Correct the Interrogator Set

TM 11-5895-1611-12&P, THE OPERATOR AND UNIT MAINTENANCE MANUAL FOR INTERROGATOR SET, AN/TPX-56(V)2, NSN 5895-01-392-2206, AND AN/TPX-56(V)3, NSN 5895-01-504-4594, NEEDS A ***CORRECTION.***

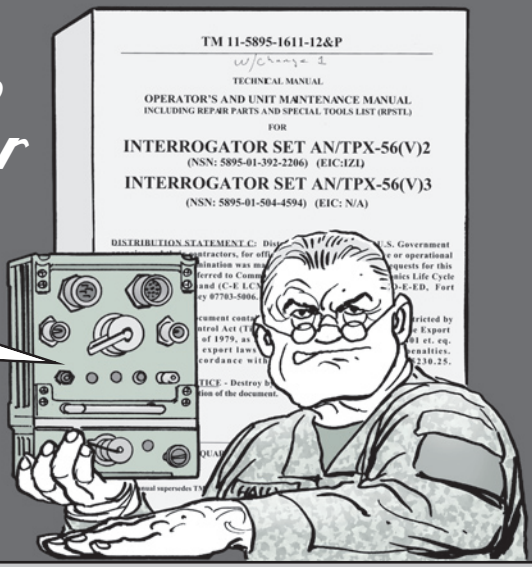
TURN TO PAGES C-13 AND C-14 AND CHANGE THE PART NUMBER AND NSN FOR THE MOUNTING BASE.

THE PART NUMBER SHOWN AS 4044526-0701 ***SHOULD*** BE 4044526-0702.

AND THE NSN SHOWN AS 5975-01-442-5552 SHOULD BE 5975-01-508-4456.

(1) Item No.	(2) SMR CODE	(3) NSN	(4) CAGEC	(5) PART NUMBER	(6) DESCRIPTION AND USABLE ON CODE (UOC)	(1) QTY
					FIG. C-3 GROUP 03: MOUNTING BASE ASSEMBLY	
	XBOOO	5975-01-461-0162	06845	4068705-0501	MOUNTING BASE ASSEMBLY..... (SEE FIG. C-1 FOR NHA)	REF
1	XBOZZ	5340-01-442-5553	06845	4068706-0501	PLATE, MOUNTING BASE.....	1
2	XBOZZ	5340-01-442-5558	06845	4068889-0702	STRAP, GROUND.....	2
3	XBOZZ	5340-01-442-5552	06845	4044526-0701	BASE, MOUNTING.....	1
		508-4456		2		
					END OF FIGURE

NATIONAL STOCK NUMBER INDEX		
STOCK NUMBER	FIGURE	ITEM
5895-01-442-5548	C-2	20
5895-01-442-7274	C-1, C-2	1, REF
5975-01-~~442-5552~~ 508-4456	C-3	3
5340-01-442-5558	C-3	2
5895-01-442-5549	C-2	9
